MEMORANDUM

To: Montgomery Township Zoning Board of Adjustment

Re: **The Malvern School Properties, LP**
Height Variance, Preliminary Site Plan and Bulk Variances
Variance Review 3
982 Georgetown-Franklin Turnpike
Block 28010, Lots 57 & 58
H-C Highway Commercial Zone

Date: June 15, 2023

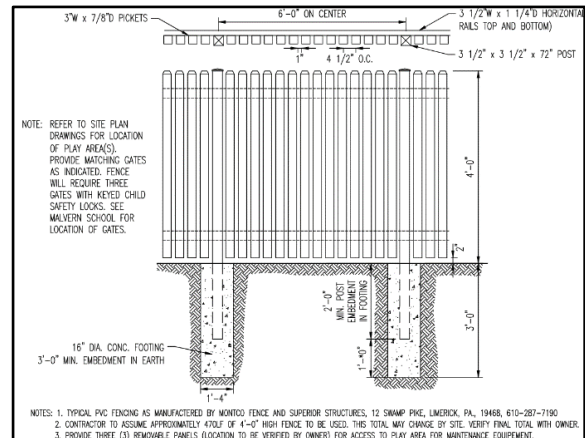
5.1. **Childcare Center Fence:** The plan indicates a fence around the childcare center. Per the detail provided (shown to the right), the fence is a vinyl board-on-board fence with child safety locks. No fence color is indicated.

Per §16-5.3b, fences shall not be erected that are higher than four (4) feet. The childcare center fence, which wraps around the two (2) sides and rear of the building, is four (4) feet in height. The plan complies.

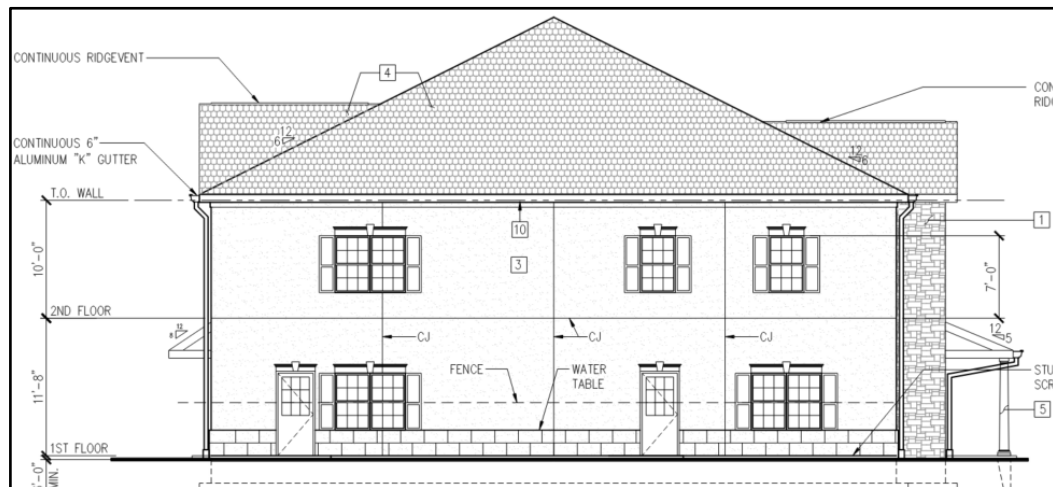
10.4. Description of Proposed Medical Facility: The medical facility (as indicated in the color rendering above) is a one (1) story building with a brick veneer base, stucco siding, hipped metal roof, topped by a parapet that is the same stucco as the center of the building. The entrance /vestibule is the tallest portion of the building, and contains a double glass door that is inset, above which is a decorative entrance, containing a roof with a decorative cornice and trim. The façade contains tall, shop style glass windows near the double doors, and single-hung, rectangular windows along the remainder of the façade. The roof is composed of gray metal. The rear of the building is similarly composed, though lacking the decorative entrance and vestibule, instead containing two (2) additional single-hung rectangular windows. The northern/left side elevation features the side of the vestibule and contains the taller, shop style windows. The remainder of the left side contains two (2) sets of four (4) single hung, thin, rectangular windows. The southern/right side elevation contains the single-hung rectangular windows found on the front and rear elevations as well as a metal rear door.

10.5. **Building Exteriors: The plan complies.** §16-4.12e.1(a) requires that building exteriors in the HC District including any accessory buildings, shall be architecturally compatible and shall be constructed of complementary materials. **Both buildings contain stucco siding, and the frontages each contain similar bases. The base around the medical building is the same throughout, while the base of the childcare facility changes to a simpler brick on the sides and rear of the building. The roof styles are different, with the medical building containing a seam metal roof, while the childcare facility contains fiberglass shingles. The stucco siding creates continuity along with the similar façade basis. Differences in the roof, windows and style of vestibule are reasonable given the different functions of the uses. While different, these elements do not clash, and can be considered complimentary. The plan complies.**

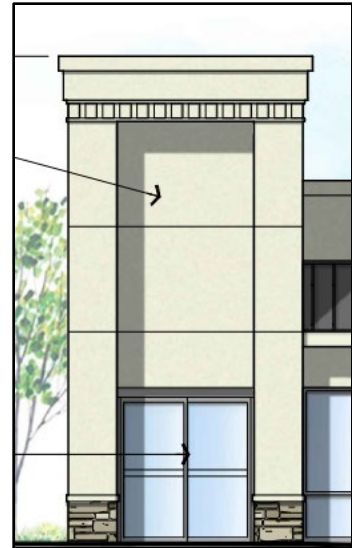
The windows do not contain lintels or pediments, however, the shop style windows constitute architectural elements, and the vestibule/main entrance contains a parapet and cornice, and the doors are inset within the overall entrance which creates a column-like feature (as indicated in the image to the right). The plan complies.
